Accessibility Review Report – DA Review

Project Title: Northside Private Hospital
Corner Racecourse Road & Faunce Street, Gosford

Job Number: 9030

Report Version: 9030_ADR_DA_v1.0

Figure 1 – Ground Floor Plan Mark-up

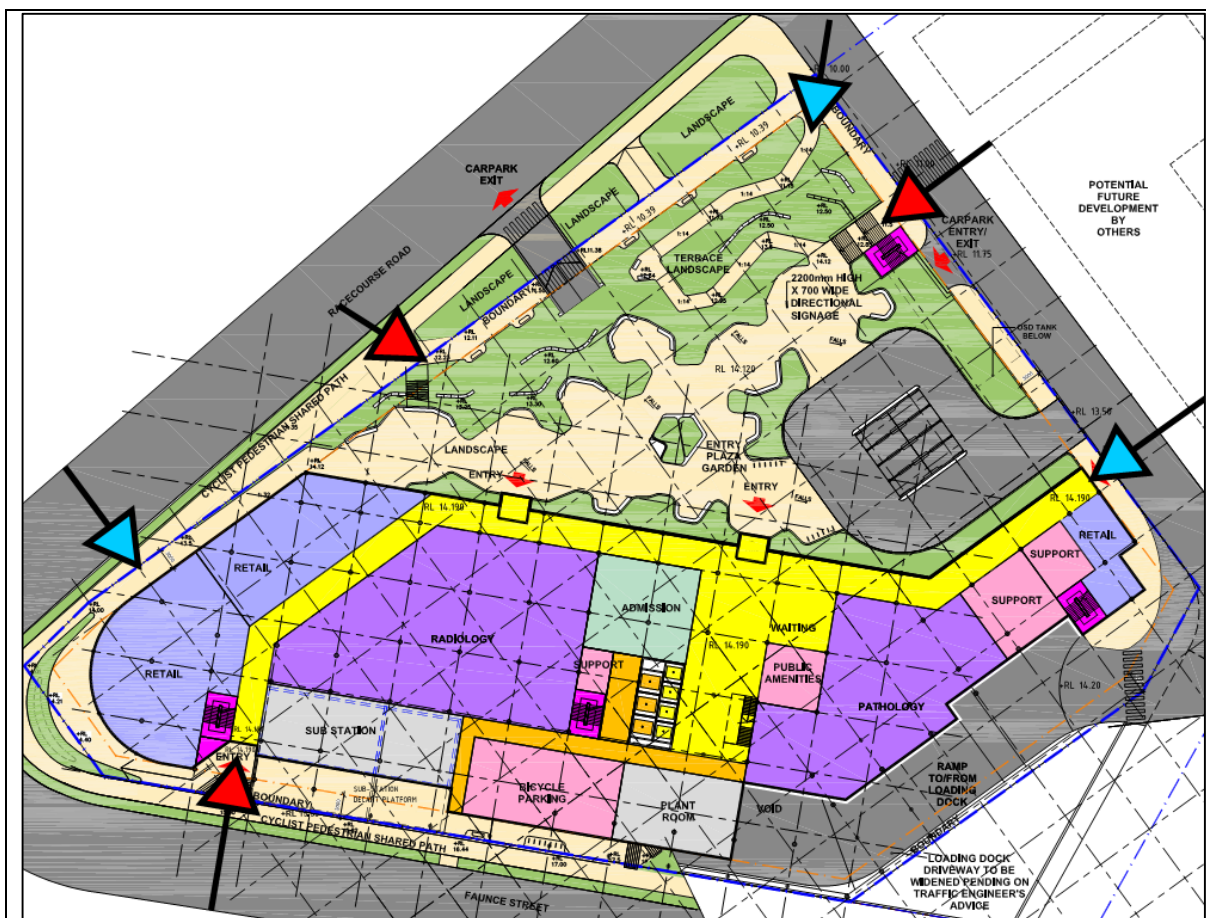
The following compliance departures are identified with the subject entries:

1. Height difference between Entry Plaza garden and internal floor level of 70mm is indicated. Step free-access is required to be provided at entrances. (RL14.12 – RL14.19)
2. Confirm a step-free entry is provided at entry from Private Road – as the RL indicated externally is 13.50.

Figure 2 – First Floor Plan Mark-up

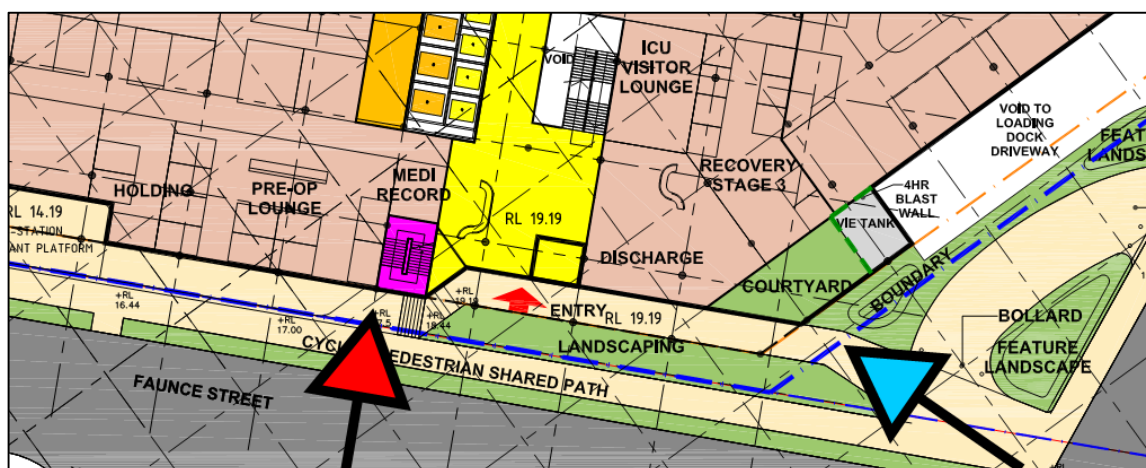
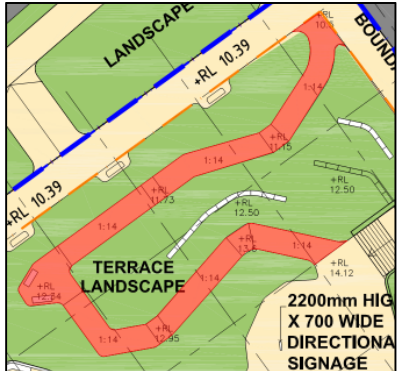
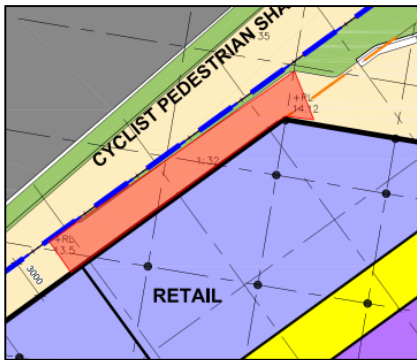
Level 1:
